Subject: AP1000 Response to Request for Additional Information (SRP 3)

Response to Request for Additional Information on SRP Section 3

RAI Response Number: RAI-SRP3.8.3-SEB1-04  
Revision: 3

Figure RAI-SRP-3.8.3-SEB1-04-01  
 Representative details at base of CA01 Module Wall with a Double Layer of Dowel Bars

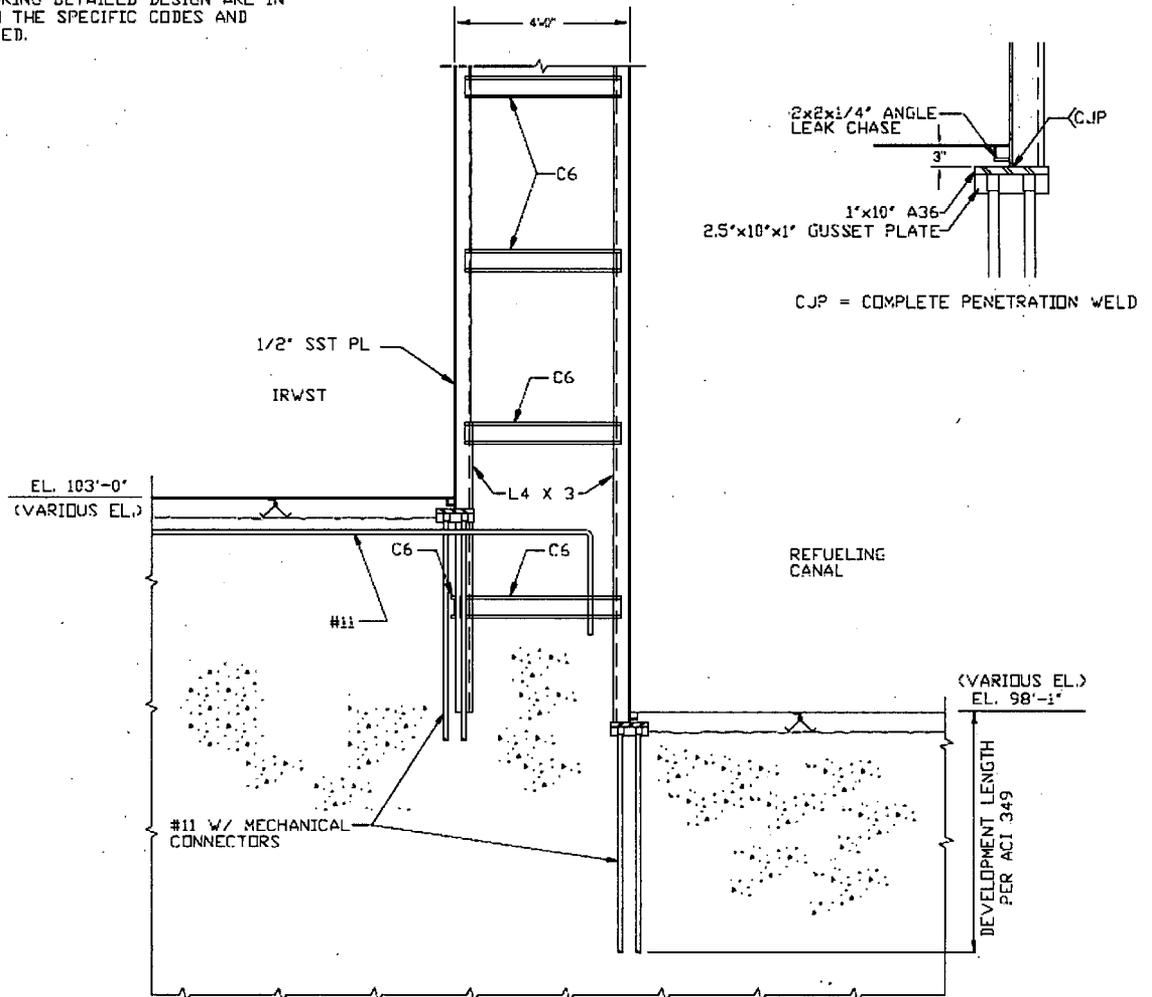
1. Explain why the horizontal #11 @ 18" rebars are identified with mechanical connectors, while no mechanical connectors are shown in the sketch.
2. Explain why the enlarged detail in the upper right corner does not show the continuity of the vertical L4 x 3 angle, which is identified in the overall connection of Figure RAI-SRP-3.8.3-SEB1-04-01A.
3. Welds for the connection on the left side of the module should be shown in the figure to demonstrate the load path from the module to the base concrete.
4. Explain why the title of the figure is labeled "...single layer of dowel bars" because the left side of the figure shows two layers of dowel bars.

For the updated DCD Figure 3.8.3-8, Sheet 2, provided in the RAI response, explain why the left hand side connection detail was replaced with the new connection detail shown in Figure RAI-SRP-3.8.3-SEB1-04-01A, rather than replacing the right hand side connection detail. This is not consistent with the text information provided in the RAI response.

(1) Because both the text of the response and Figure RAI-SRP-3.8.3-SEB1-04-01 indicate that the mechanical connection detail illustrated in the figure is a representative connection detail that will be used, a note should be added to the figure that any deviation to the detail shown shall maintain a direct load path to transfer loads from both sides of the module surface plates to the vertical dowel bars in the base concrete through the use of intervening plates, mechanical connectors, and welds.

Westinghouse will remove the "alternate" detail with the lapped splice, and provide mechanical connection of the structural modules to the base concrete using reinforcing bars and mechanical connectors. The mechanical connection detail illustrated in Figure RAI-SRP-3.8.3-SEB1-04-01 is representative of the connection that will be used. This mechanical connection consists of a base plate welded to the CA module liner plate, with gusset plates and vertical reinforcing bars attached to the underside of the base plate. DCD figure 3.8.3-8 is modified to reflect changes to the connection, including deletion of lap splice details. The details presented as typical are intended to provide clarity of the design intent, but not to supersede any changes necessary to accommodate features needed to ensure functionality of the design.

Figure RAI-SRP-3.8.3-SEB1-04-01 in the previous response is replaced by a revised Figure RAI-SRP-3.8.3-SEB1-04-01 which includes revisions to respond to the previous comments. The items listed in the question related to the revised typical detail shown in Figure RAI-SRP-3.8.3-SEB1-04-01 (Figure 01A in Rev 1 response) are addressed below.

1. The horizontal #11 @ 18" rebars are incorrectly identified with mechanical connectors. These bars terminate with hooks as shown in the sketch. This figure has been revised.
2. The enlarged detail in the upper right corner shows a section midway between the vertical L4 x 3 angles. As shown in Figure 3.8.3-SEB1-04-02, the base plate is not continuous across the vertical angles. This design will be clarified in implementation of the changes described in this response.
3. Welds for the mechanical connection have been added to the figure to demonstrate the load path from the module to the base concrete.
4. The title of the figure has been revised to show "...double layer".

Changes to the mechanical connector detail shown will maintain a direct load path to transfer loads from the module face plates to the reinforcement bars in the base concrete through the use of intervening plates, mechanical connectors, and welds.

Figure RAI-SRP-3.8.3-SEB1-04-02

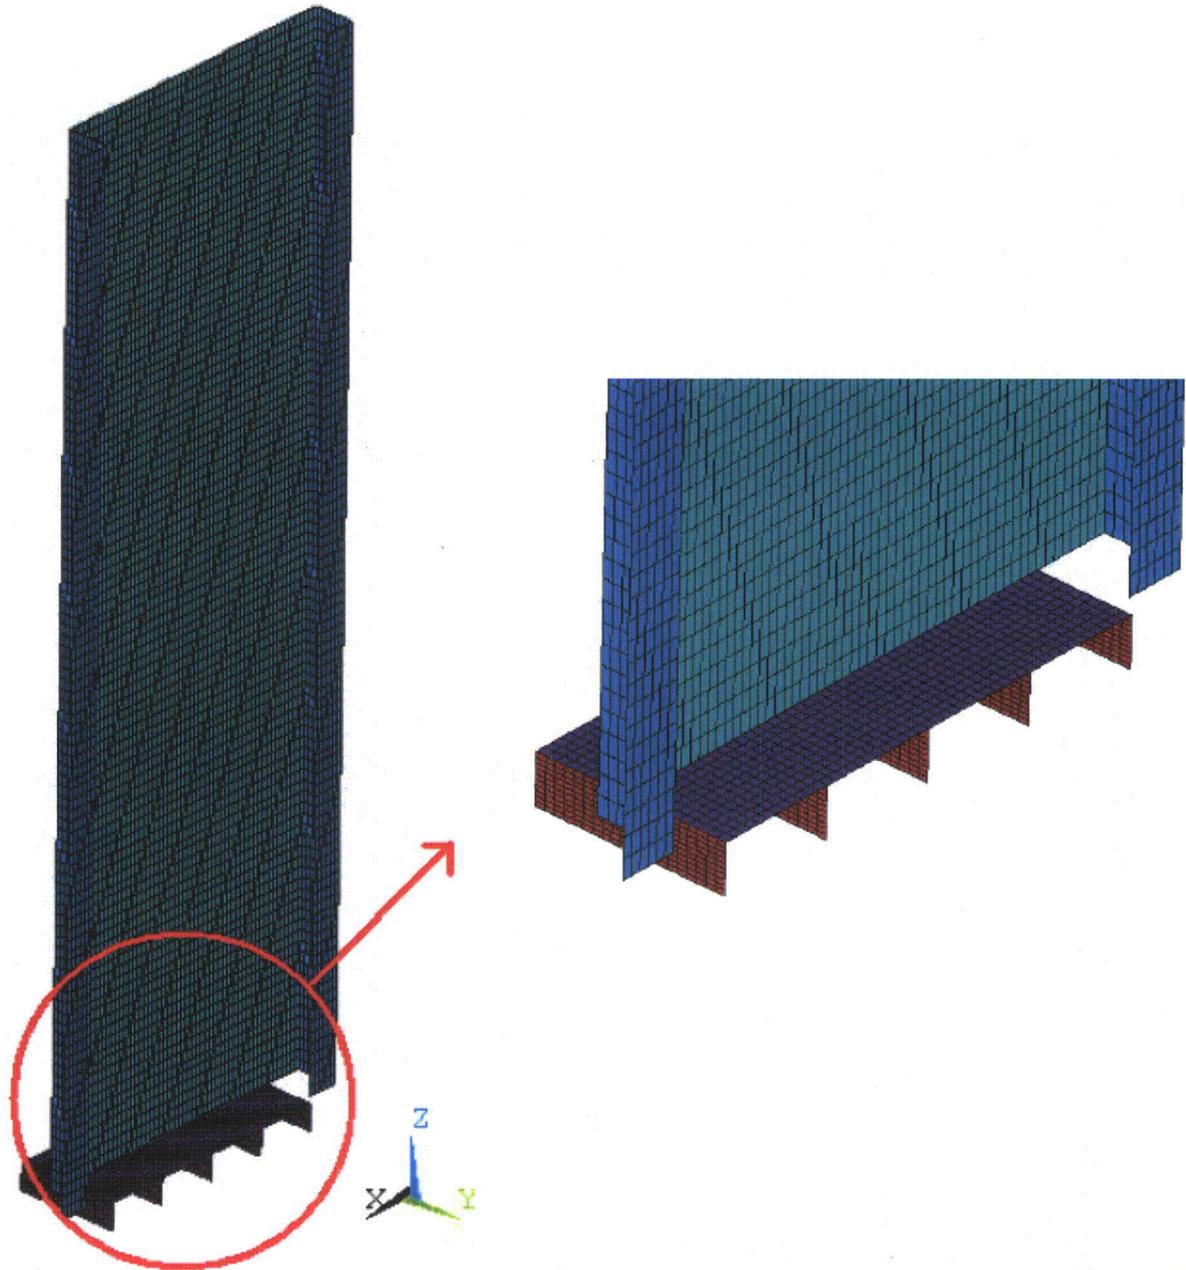
2. The right side of Figure 3.8.3-8, sheet 2 shows #11 at 10 inch spacing span from the embedded basemat region into the wall module with about 3 inches of concrete cover. Since this type of connection is not addressed in ACI 349, describe how the loads from the module can be properly transferred from the module to the embedded bars in the basemat and how the design will be performed. When this detail was discussed with Westinghouse at an earlier audit this year, Westinghouse indicated that they would consider removing this second option.

~~An alternate version of this detail is used in cases where the trusses are extended into the basemat as shown in RAI-SRP-3.8.3-SEB1-04-02. The vertical dowel bars are placed in two layers. The base plate is stiffened to transfer the loads from the module wall plate to the embedded connectors. The design of the surface plate, base plate, and vertical stiffeners is checked by finite element analysis using the model shown in Figure RAI-SRP-3.8.3-SEB1-04-03. Tension corresponding to yield is applied to each dowel bar. These design calculations have been completed.~~

- ~~This connection has been removed as an option, and loads are transferred directly from the faceplates to the base concrete using vertical bars and mechanical connectors. The right side of Figure 3.8.3-8, sheet 2 shows a dowel bar adjacent to the surface plate. The design of this type of connection is based on recommendations and test data given in Reference 1. The reference provides a design equation to calculate the strength of the connection based on key parameters such as concrete strength, dowel bar length and spacing, and concrete cover. This detail may be used when loading on the surface plates is within the range of the test data. It is used at the base of the CA05 module inside containment and the CA20 module outside containment where design loads are smaller.~~

Replace Figure 3.8.3-8 (Sh2 of 3) with New Figure RAI-SRP-3.8.3-SEB1-04-01

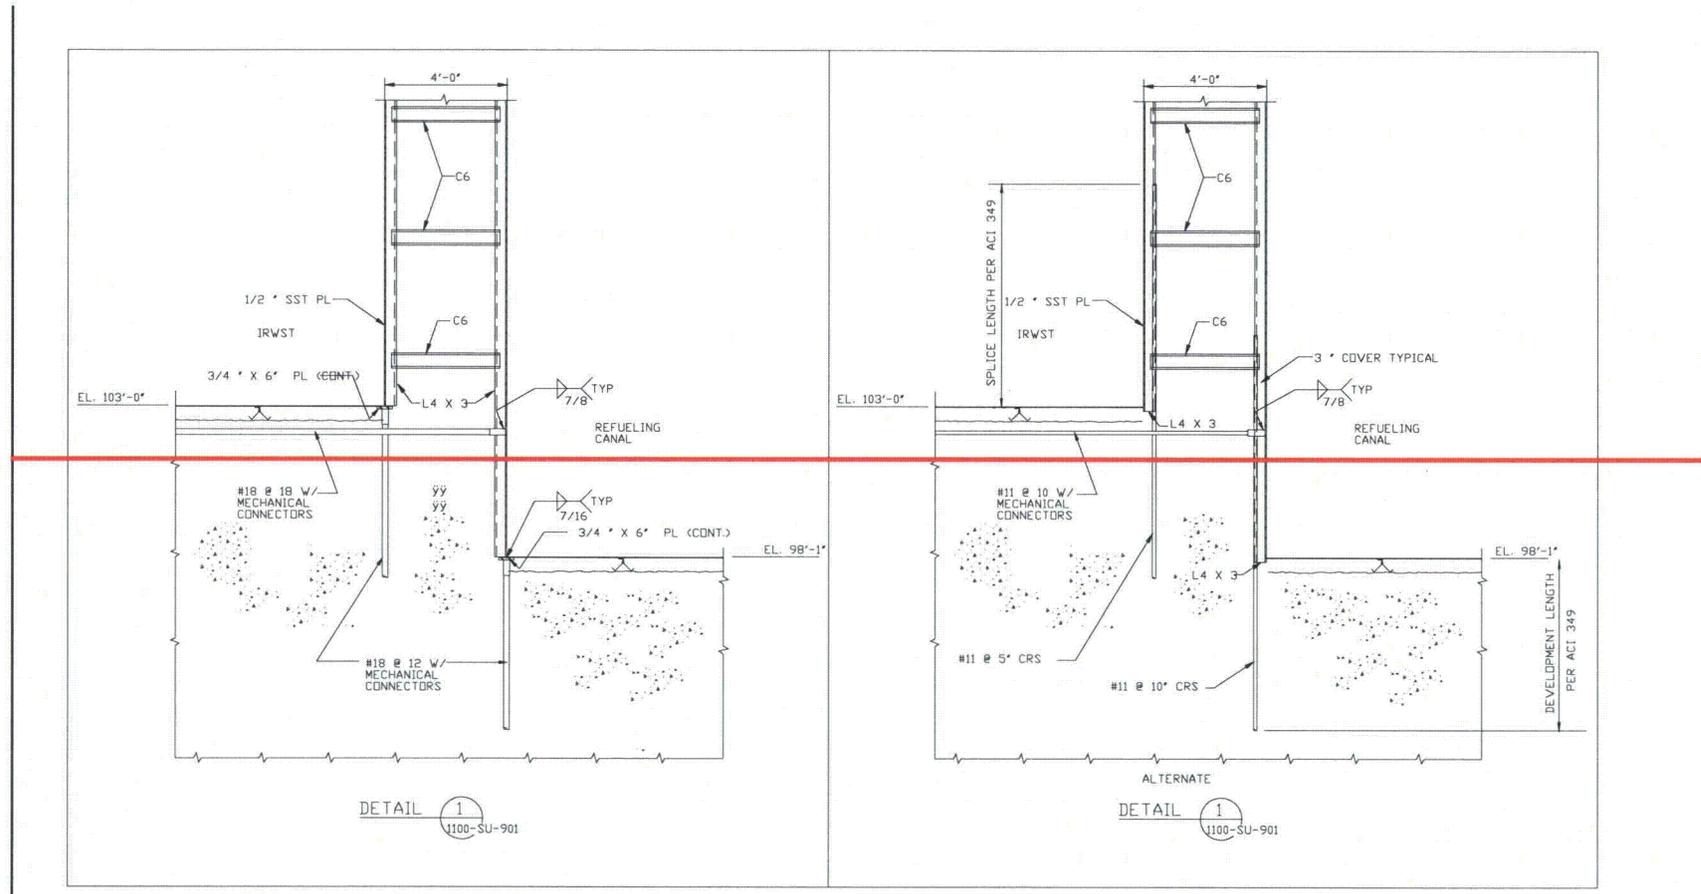
1. The left side of Figure 3.8.3-8, sheet 2, shows that the mechanical connectors that are welded to a  $\frac{3}{4}$  inch plate at the base of the module is identified as "CONT" (presumably meaning continuous) on one side of the module and on the other side the term "CONT" is struck out. Explain which detail is correct and revise the figure accordingly. Were the design detail calculations completed for this connection? Explain how the large loads coming from the CIS wall modules can be properly transferred from the module wall plate at a localized point to the embedded connectors.

(2) Correct the typo on Page 4 of 7 of the response and under "Design Control Document (DCD) Revision." In the phrase, "The updated DCD Figure 3.8.3-8, Sheet 2 is provided on Page 6 of this response," "Page 6" should be "Page 5."

Revise DCD Rev 17 Figure 3.8.3-8, sheet 2 of 3. The updated DCD Figure 3.8.3-8, Sheet 2 is provided on Page 6 of this response.

The following note will be added to Figure 3.8.3-8,
